JOHN AND DEBRA WILLIAMS
SUBDIVISION

FINAL PLAT

Re: S/D 96-52 - JOHN AND DEBRA WILLIAMS ADDITION (Final Plat)

CASE NUMBER: S/D 96-52 JOHN AND DEBRA WILLIAMS ADDITION

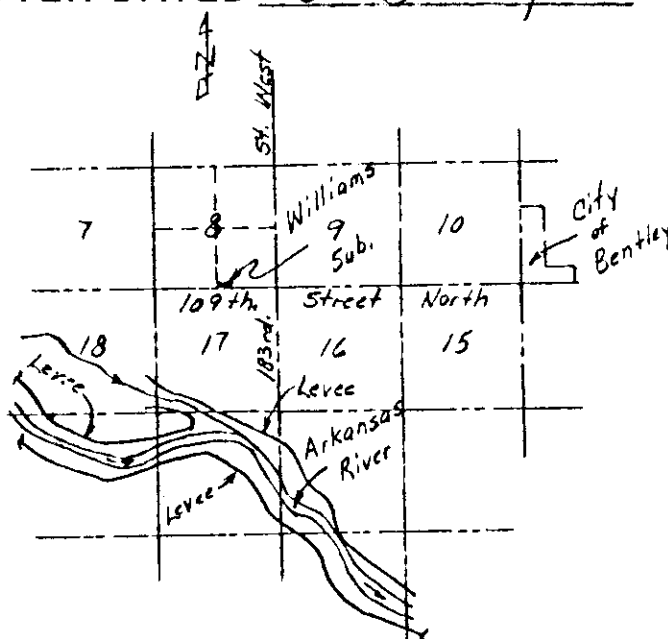
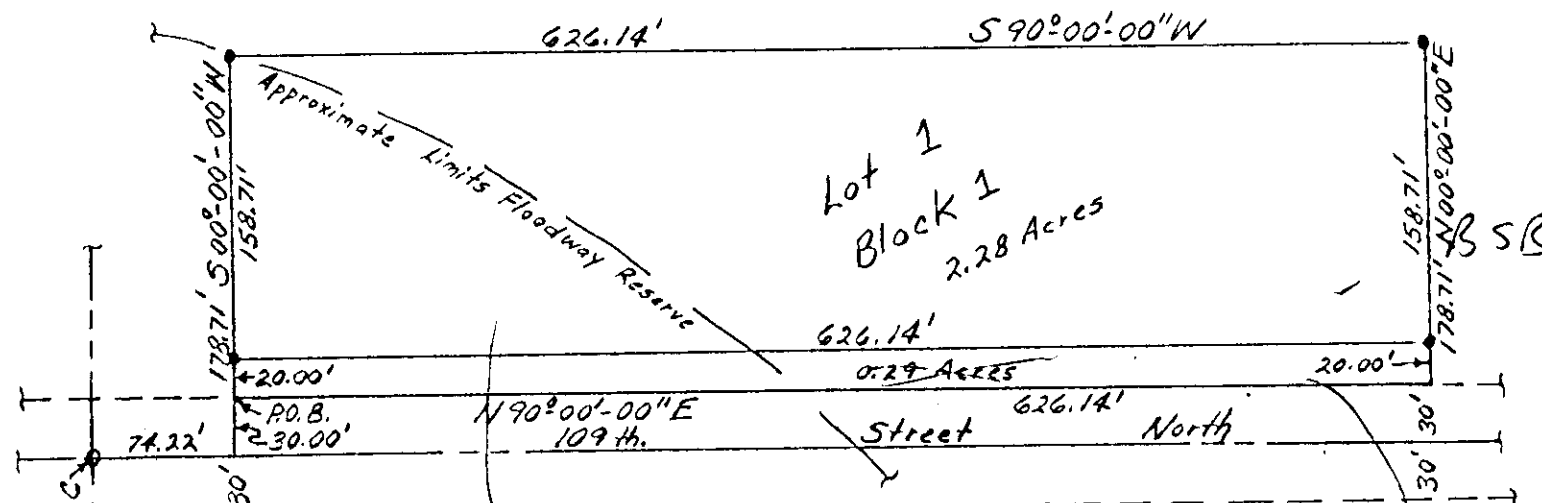
Handwritten notes:
- Flowway long
- Min. 1/2" Iron Set with Cap No. 1207
- Health
- AC
- Clearly Note R.O.W. do not on solid
- Delete .294 sq row

- ~~**D.**~~ On the final plat tracing, the face of the plat shall clearly label the area of street dedication and this area shall be shown in a more specific manner from the adjoining lot. Dashed lines, fainter lines, etc. should be used for the 20-foot dedication so as to make it distinctly separate from the adjoining lot. The .29 Acre noted in the area of dedication shall also be deleted.

- ~~**E.**~~ The final plat tracing shall indicate a 30-foot building setback to 109th Street North.
- ~~**F.**~~ The face of the plat shall also note the dedication of the access control as stated in the platlor's text.

- G. On the final plat tracing, a tie point shall also be shown on the face of the plat.
- H. The final plat tracing shall indicate a minimum building pad elevation as required by County Engineering. Both the plat's text and face of the plat shall note such an elevation. Also, both an on-site and off-site benchmark shall be shown.

- P. Prior to the plat tracing being released for County Commission scheduling, the applicant shall have submitted to County Engineering a drainage plan and such drainage plan shall have been approved. The final plat tracing shall also accurately depict the boundary of the floodway reserve. Before or with the submittal of the plat tracing to Planning, the applicant shall provide a letter from County Engineering indicating the satisfaction of these requirements.
